OWNER CHANGE ORDER

NO.: 007

TITLE: OCO #007 - PCI: # 28, #29, #31, #32, #34 & #35
PROJECT: Magnolia Science Academy
TO: Magnolia Educational and Research Foundation
250 E. 1st St., 1500
Los Angeles, CA

DATE: 05/15/2019
PROJECT NO.: 18049
CONTRACT: 18049

1 BUILDING SECTION
S4.0 SCALE: 1/4"=1'-0"
NOTES:
1. FOR INFORMATION NOT SHOWN SEE ARCH'L
PLANS SECTION 1/AS.1
2. ELEVATION TO BE VERIFIED W/ARCH'L PLANS
3. FOR JOISTS/BEAMS/DECK DIRECTION
SEE PLANS

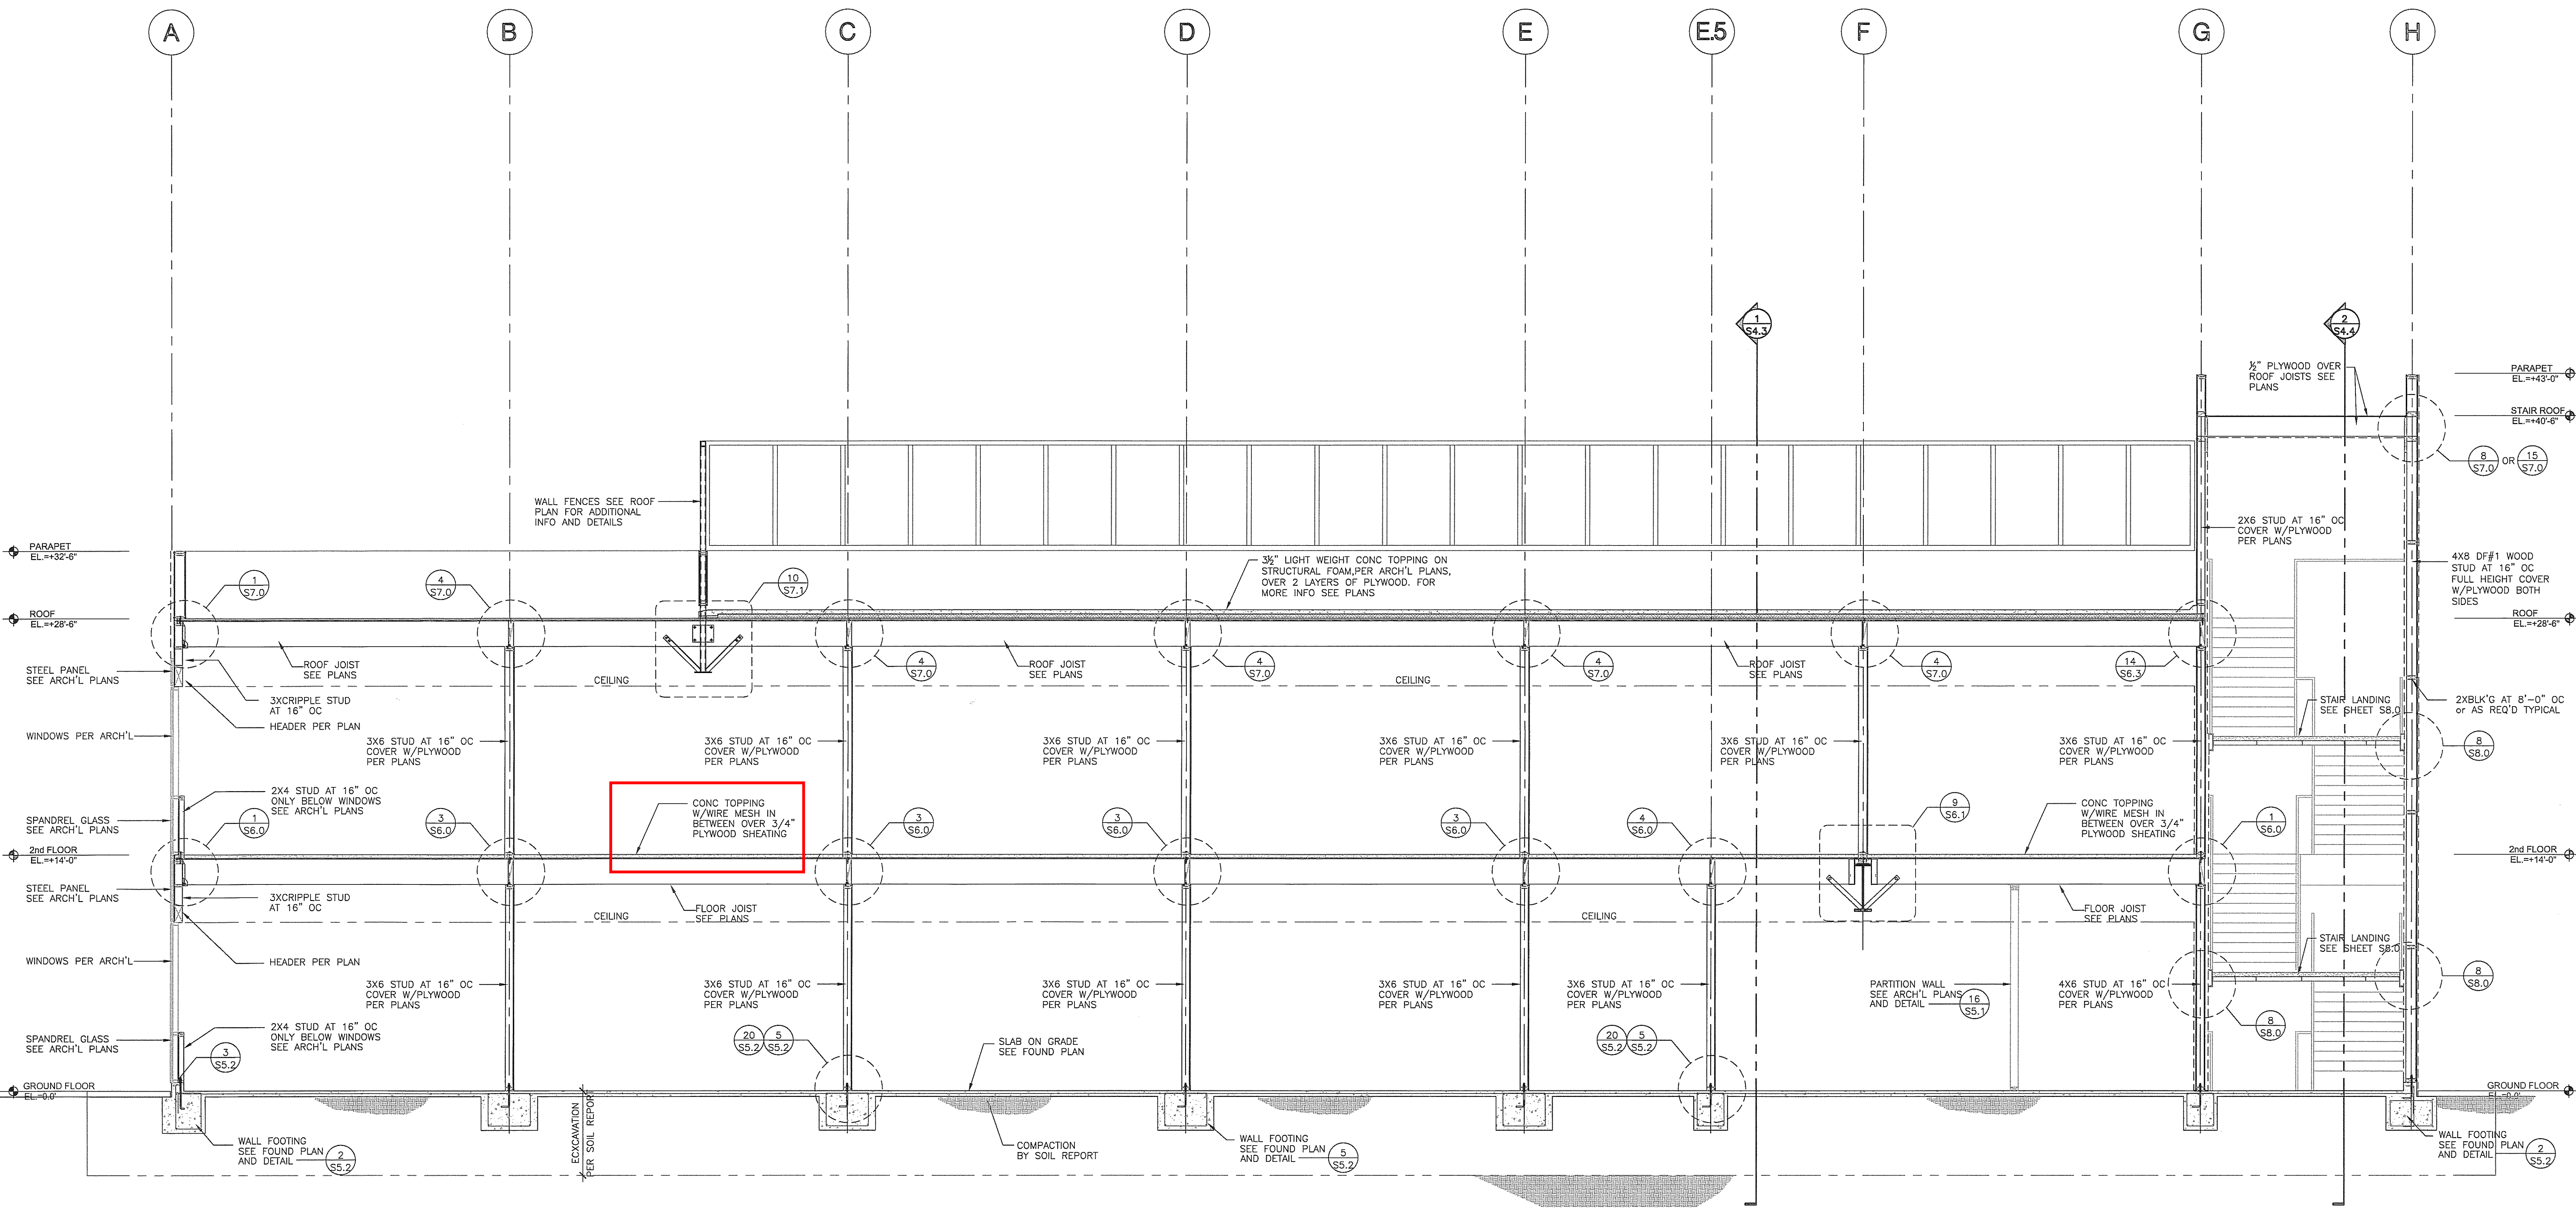
1. The concrete topping on 2nd floor over plywood is not a standard decking detail and we would like to ensure we are meeting design intent and general functionality.
 - a. Please confirm the +/-2.5" concrete topping slab (4000psi) over ¾" plywood on the 2nd floor is to receive wire mesh per S4.0.
 - b. Please confirm there is NO relief/soft cuts required for this slab.
 - c. Please advise if there are any pre-loading or shoring requirements for the 2nd floor and rooftop decks.

1. The floor joists and plywood are designed to support the light weight concrete topping.
 - a. Please make sure the concrete is LIGHT WEIGHT CONCRETE. The concrete topping slab receives wire mesh per notes 1 on sheet S2.0.
 - b. No relief/soft cuts is required
 - c. No pre-loading or shoring is required. The plywood and roof/floor framing is designed to support the extra concrete weight. Please make sure all the roof/floor framing and diaphragm are constructed per approved structural set first. Then the concrete topping can be constructed.

PROJECT	MAGNOLIA SCIENCE ACADEMY
PROJECT ADDRESS	18220 SHERMAN WAY, RESEDA, CA 91335
DATE	2/17/2017
DESIGNER	AS NOTED
SCALE	E2.1

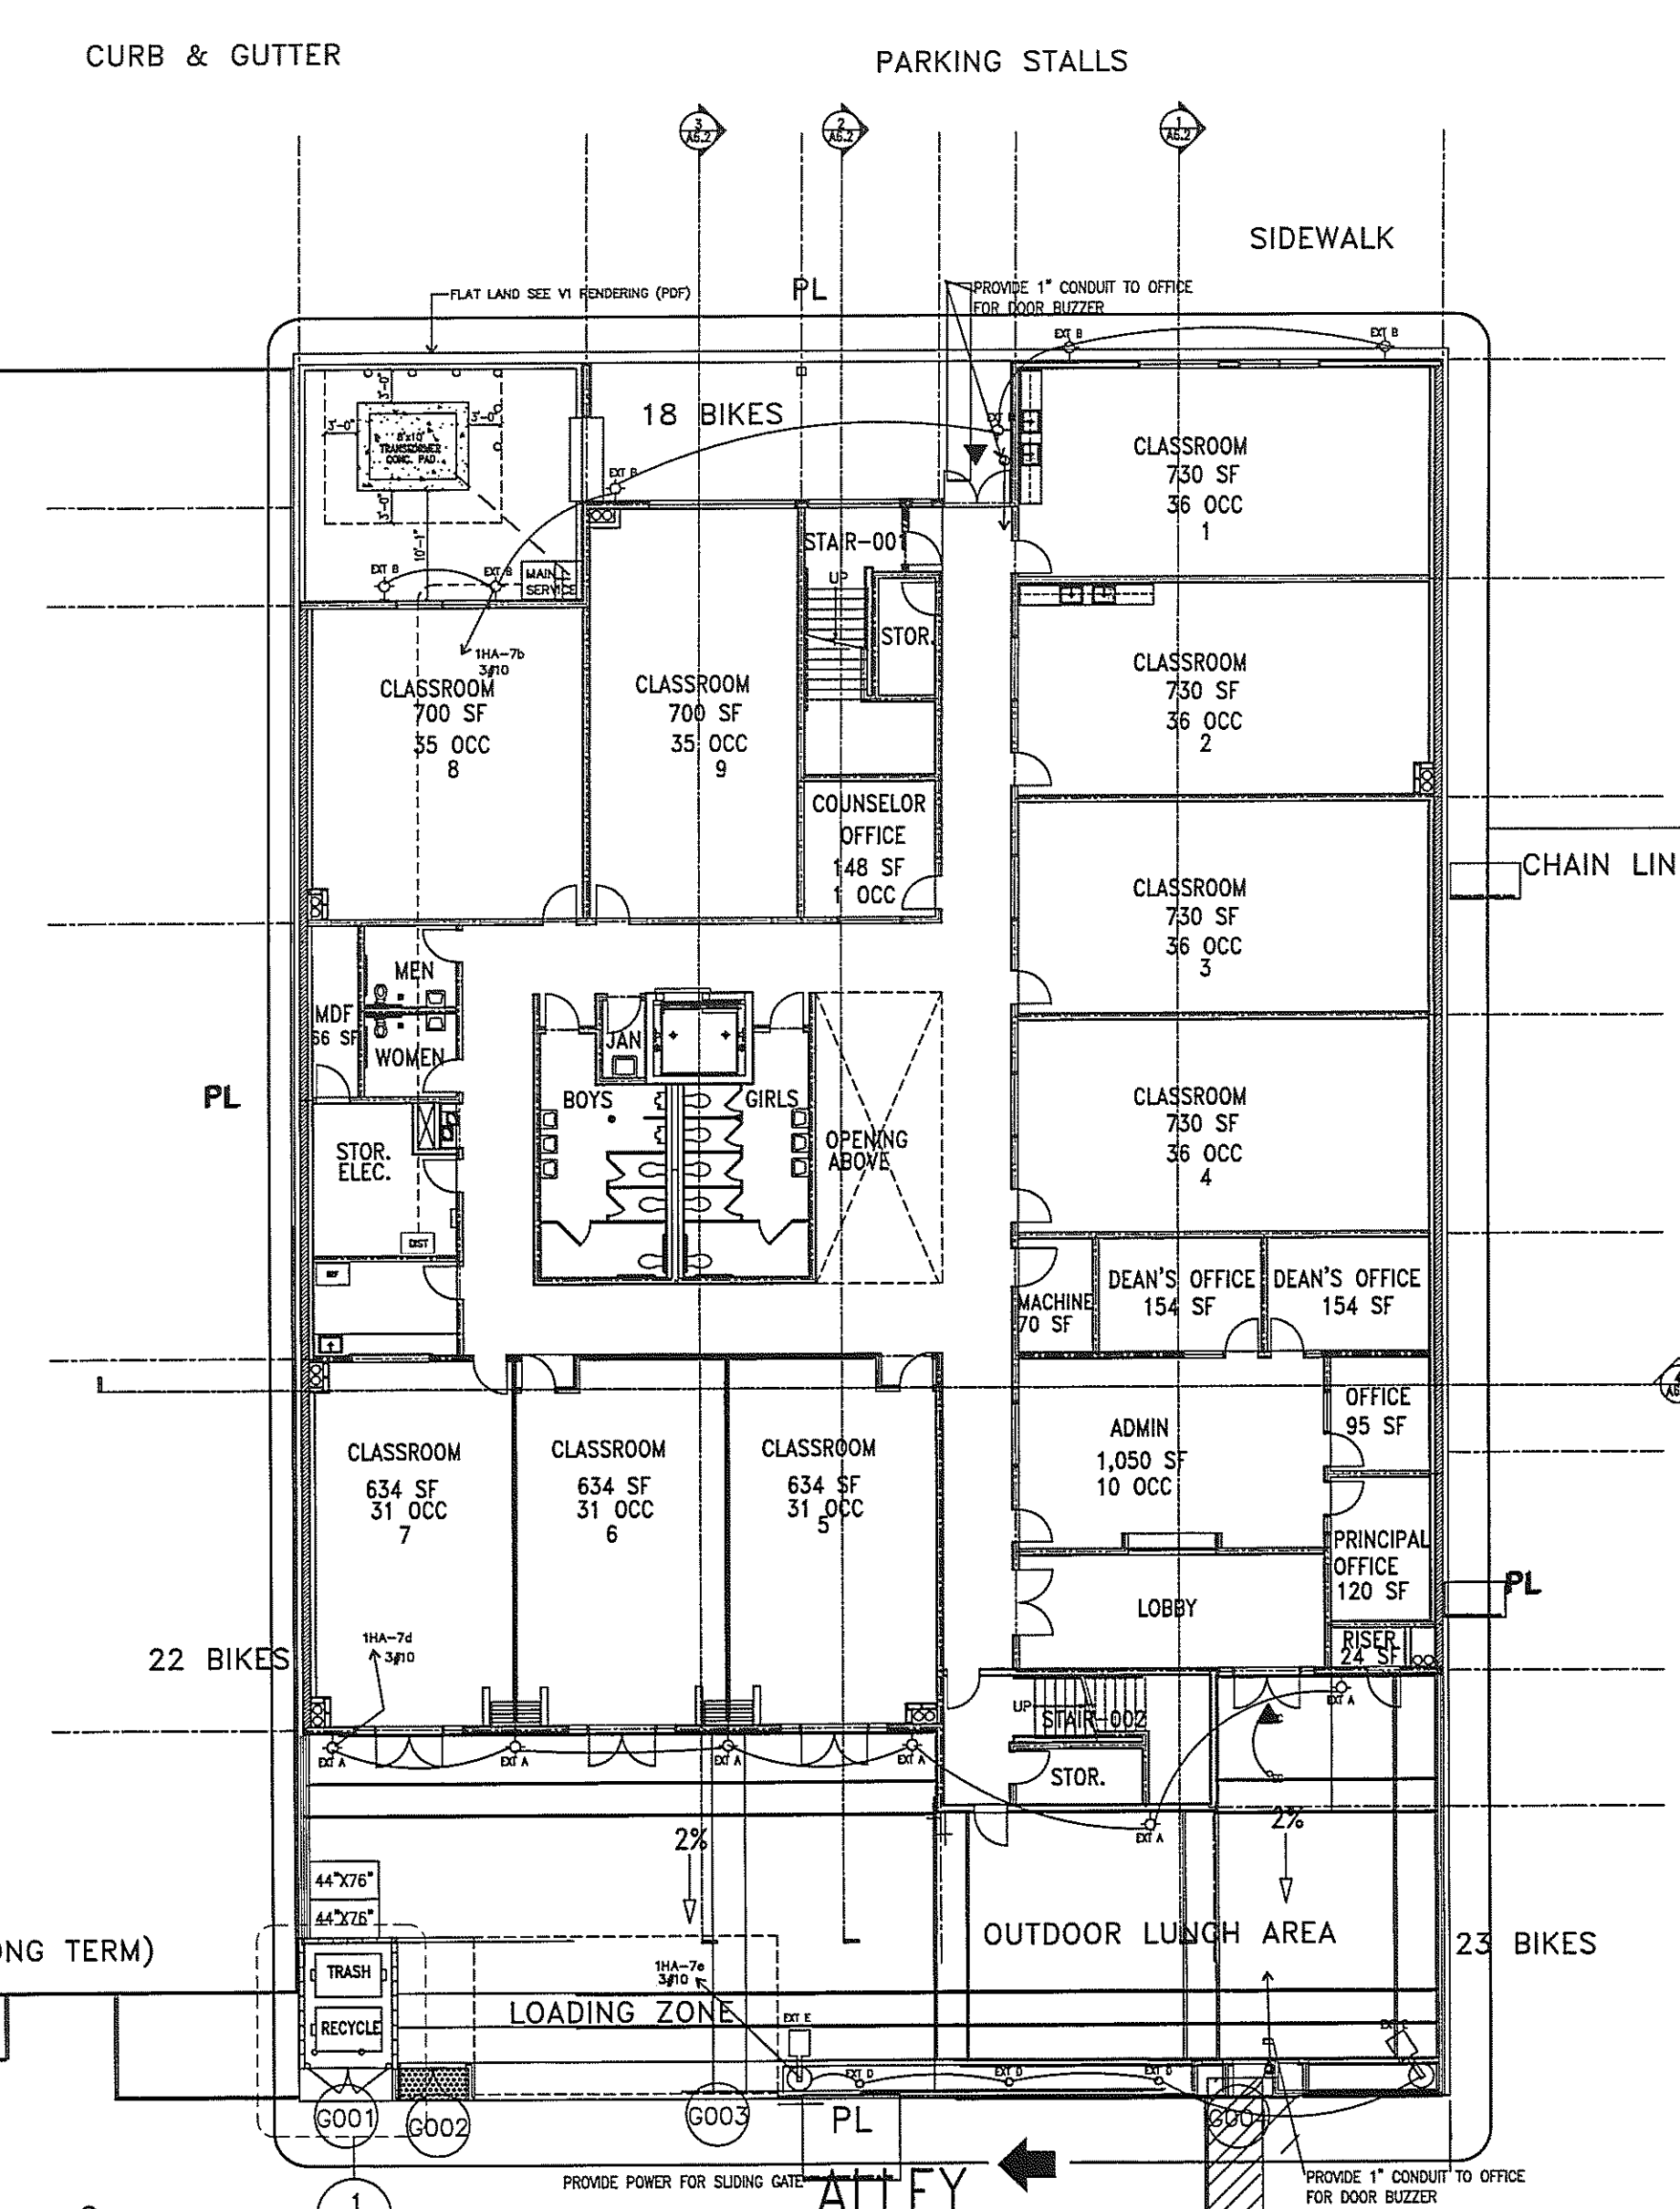
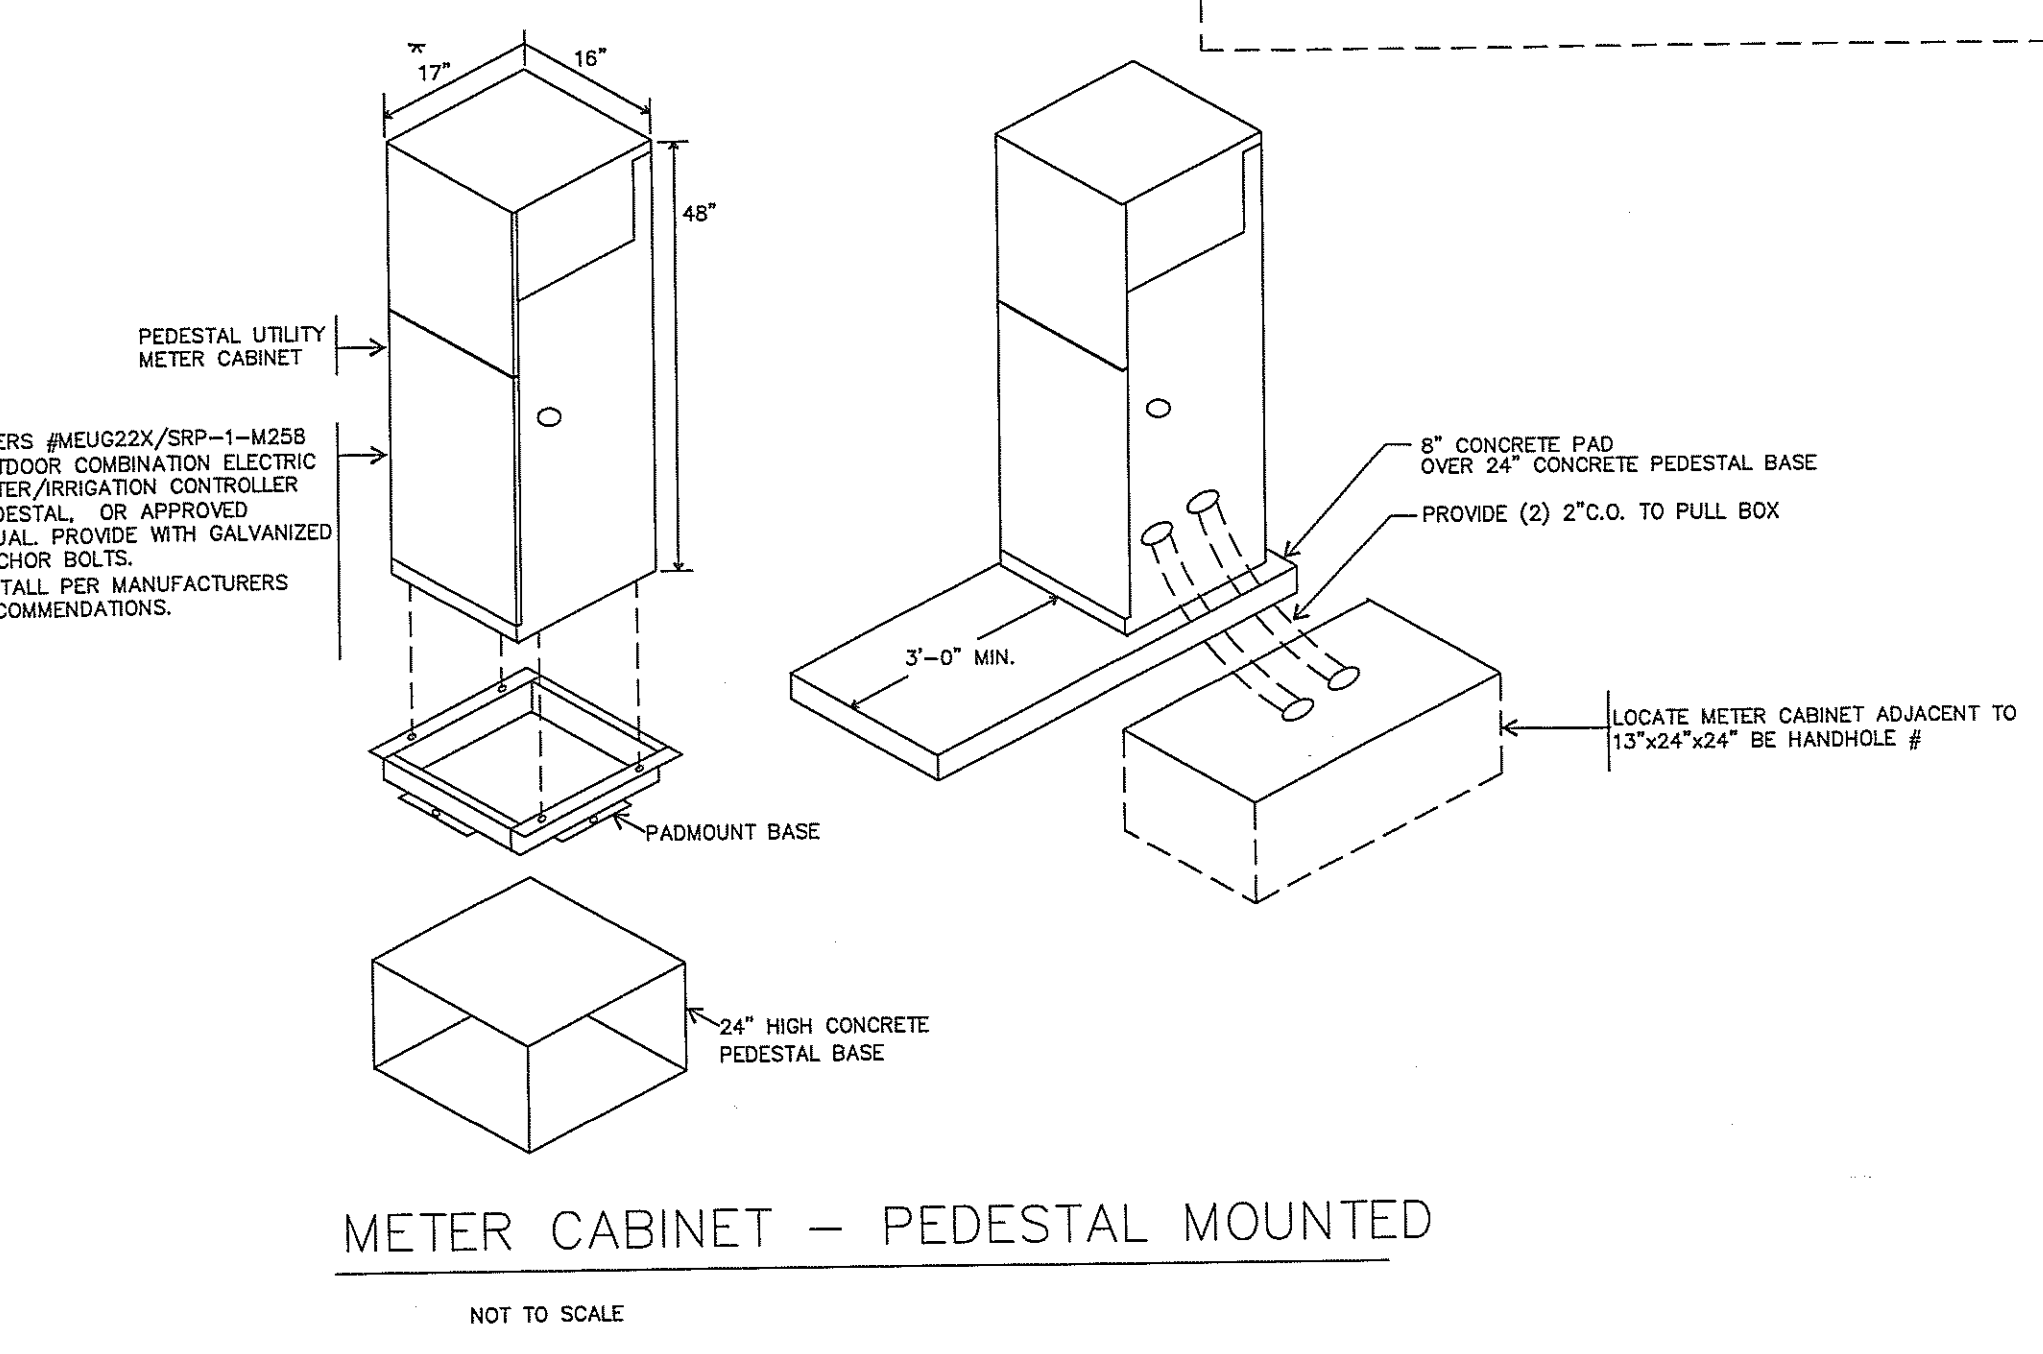
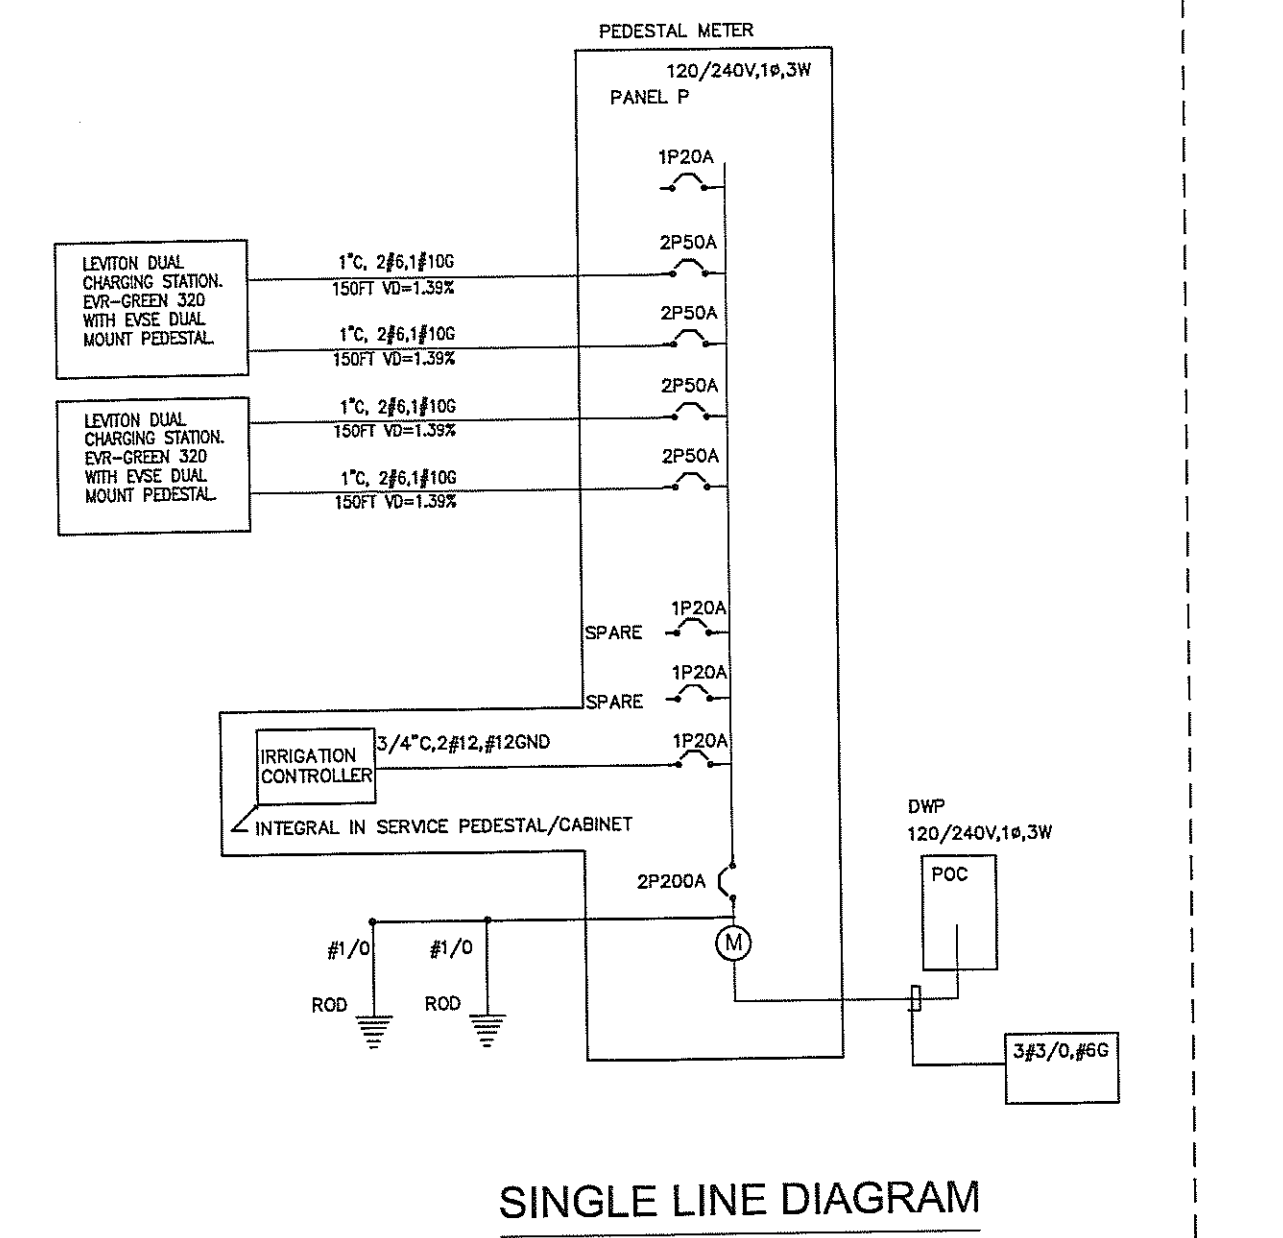
This Potential Change Item (PCI) tracks costs associated with the added labor, materials, and equipment required to install the added LADWP electrical pole not previously included in our scope. Reference E2.1 for site plan.

DWP has advised that the Owner needs to install a new pole to feed the new electrical equipment (LADWP page 7-28 Design & Installation Guide for Overhead Services, 0-600 volts sheet)
